ADDENDUM No. 1

ITB No. 4550

WTP Ozone Generation Building Chiller Replacement

Title
ELECTRICAL
NEW WORK PLAN
480V

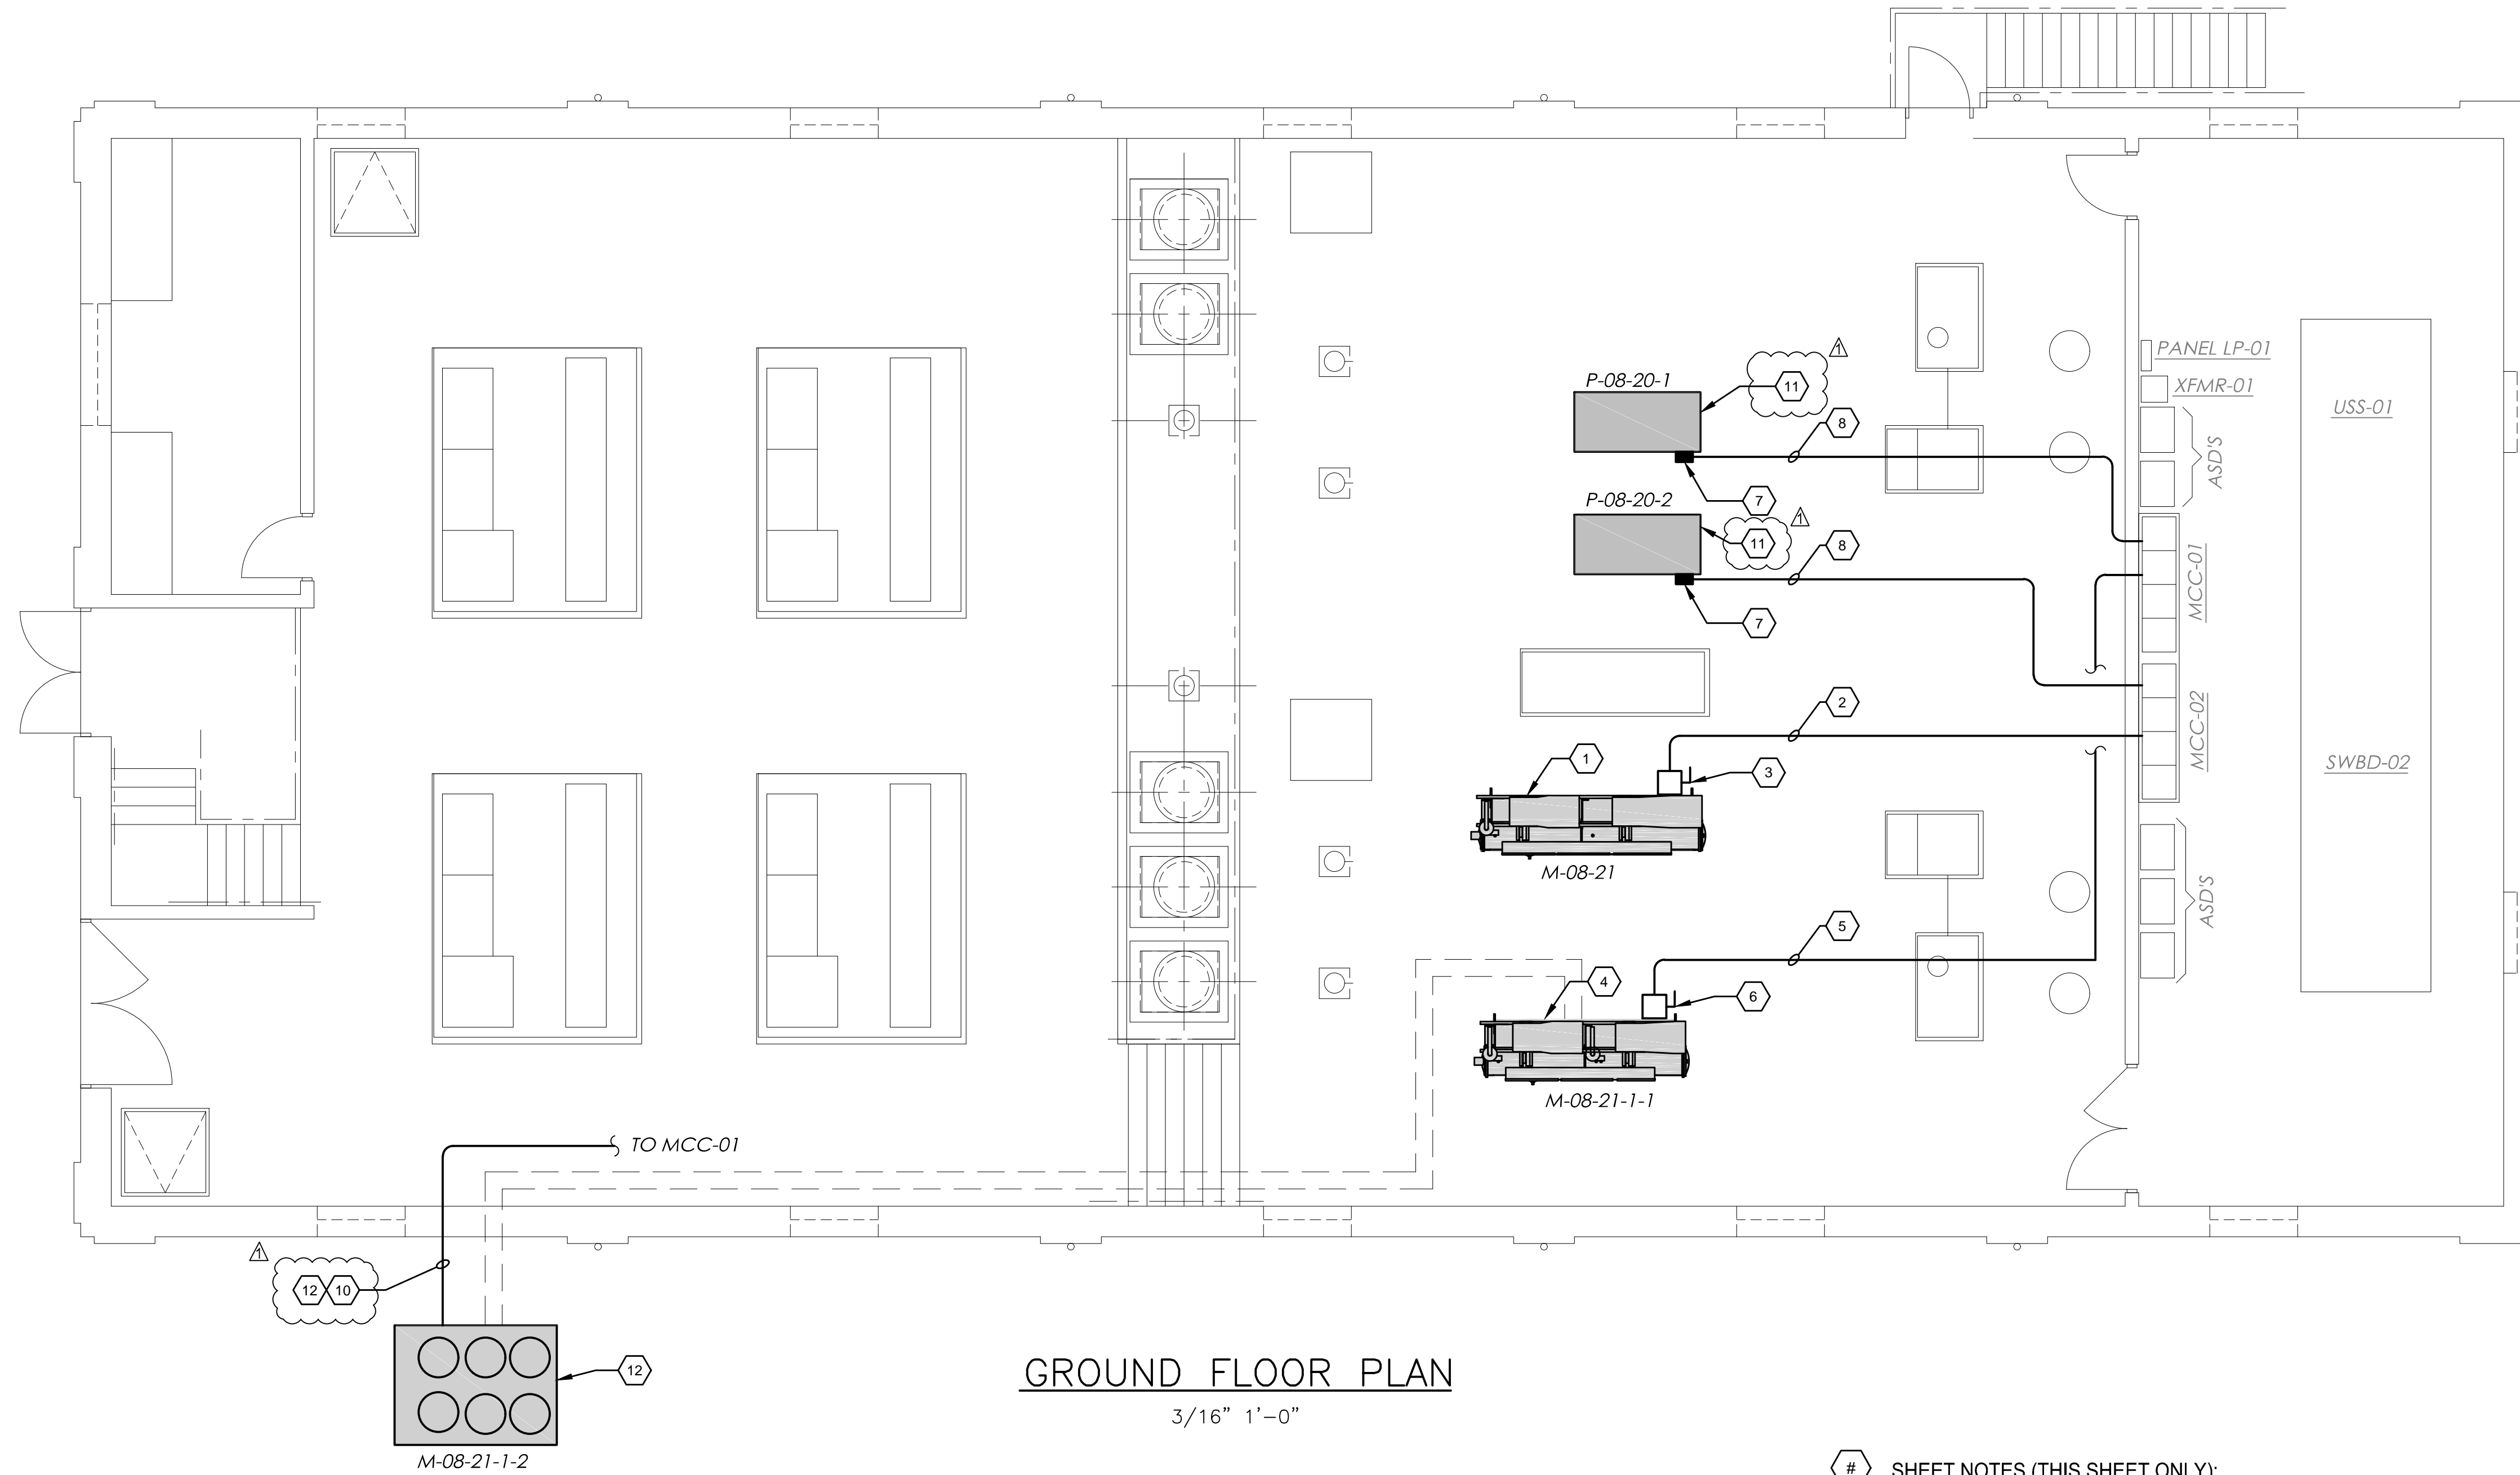
1. NEW 100 TON CHILLER.
2. EXISTING CHILLER FEEDER TO BE RE-USED, EXTEND WITH 2" RGS WITH 3 - #2 & #4 GND AS REQUIRED.
3. 400A NEMA 1 1/2R FUSED DISCONNECT.
4. NEW 40 TON CHILLER.
5. EXISTING CHILLER FEEDER TO BE RE-USED, EXTEND WITH 1 1/2" RGS WITH 3 - #1 & #6 GND AS REQUIRED.
6. 200A NEMA 3R FUSED DISCONNECT.
7. 40 HP, 480V, 3Ø, VARIABLE FREQUENCY DRIVE, NEMA 1/12 MOUNTED ON S.S. UNISTRUT TOWER.
8. 1" RGS WITH 3 - #6 & #8 GND.
9. EXISTING CONDENSER FEEDER TO BE RE-USED, EXTEND WITH 3/4" RGS WITH 3 #12 & #12 GND AS REQUIRED.
10. NEW 40 TON OUTDOOR CONDENSER.
11. NEW COOLING WATER PUMPS AND MOTORS.
12. EXISTING UNDERGROUND CONDUIT TO BE REPLACED W/ PVC SCHEDULE 80. CONDUIT TO BE A MINIMUM OF 36" BELOW GRADE W/ EXPANSION JOINTS AS REQUIRED.
